TECHNICAL BULLETIN
Bell Helicopter **TEXTRON**

No. 205-04-116

SUBJECT: CHIP DETECTOR INDICATOR, REPLACEMENT FOR SPARES

Bell Helicopter has become aware that screen assy P/N 209-075-227-001 , switch P/N 2D9 and indicator P/N 2C212 are no longer available. These parts are used in the Chip Detector system. This bulletin introduces a new Indicator retrofit Kit 212-704-165-105.

Fig 3

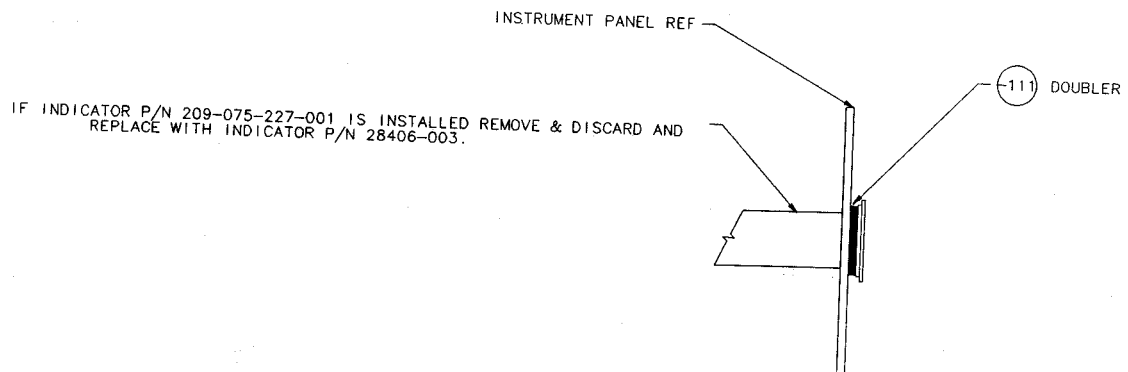
1. Disconnect battery.
2. Gain access to the back of chip detector indicator located on the instrument panel.
3. Disconnect wires from chip detector indicator.
4. Using fig 2, delete wires as mentioned.
5. Remove and discard chip detector indicator from instrument panel.
6. Install new chip detector indicator in conjunction with doubler –111 as shown in fig 3.
7. Using fig 1, 4 and BHT-ELEC-SPM section 4-4 relocate and connect wires on previously installed indicator.
